Access Compliance Report

Public Rights-of-Way

(Curb Ramps)

Intersection ID: 48947	Main Street: DAVID_JENNINGS_AV	Cross Street: PEPPERPIKE_WY	Location: E
ADA ID: 18DB0B96A98A	Ramp Type: Perp	Initial Pass/Fail: Fail	Overall Compliance: No
		Severity Score: 8.75

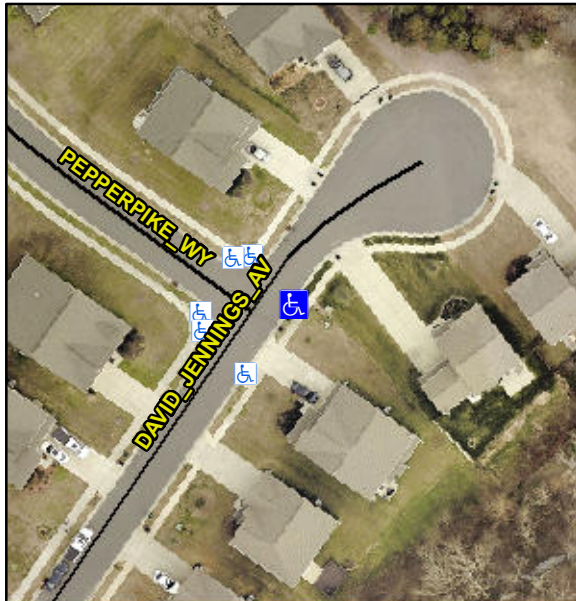
Not Found, R304.5.1

Compliance	Description	Data	Compliance	Description	Data
N/A	Ramp Length (in)	46.0	Yes	Ramp Slope (%)	7.3
No	Ramp Width (in)	47.5	Yes	Ramp XSlope (%)	0.2
N/A	Flare Type LT	N/A	N/A	Flare Type RT	N/A
N/A	Flare Slope LT (%)	N/A	N/A	Flare Slope RT (%)	N/A
N/A	Flare Traversable LT?	N/A	N/A	Flare Traversable RT?	N/A
N/A	Landing Length (in)	N/A	N/A	DWS Provided?	N/A
N/A	Landing Width (in)	N/A	N/A	DWS Contrast?	N/A
N/A	Landing Slope (%)	N/A	N/A	DWS Length (in)	N/A
N/A	Landing X Slope (%)	N/A	N/A	DWS Full Width?	N/A
N/A	Landing Curb? (Y/N)	N/A	N/A	DWS Offset (in)	N/A
N/A	Shared Landing?	N/A			
N/A	Gutter Ponding?	N/A	N/A	Gutter Slope (%)	N/A
N/A	Gutter Lip Ht (in)	N/A	N/A	Gutter X Slope (%)	N/A
N/A	Painted X Walk1?	No	N/A	Painted X Walk2?	N/A
	X Walk 1 Direction	To NW		X Walk 2 Direction	N/A
N/A	X Walk 1 Width (in)	N/A	N/A	X Walk 2 Width (in)	N/A
	X Walk 1 Slope (%)	1.7		X Walk 2 Slope (%)	N/A
	X Walk 1 X Slope (%)	1.5		X Walk 2 X Slope (%)	N/A

Remove & Replace Entire Ramp.
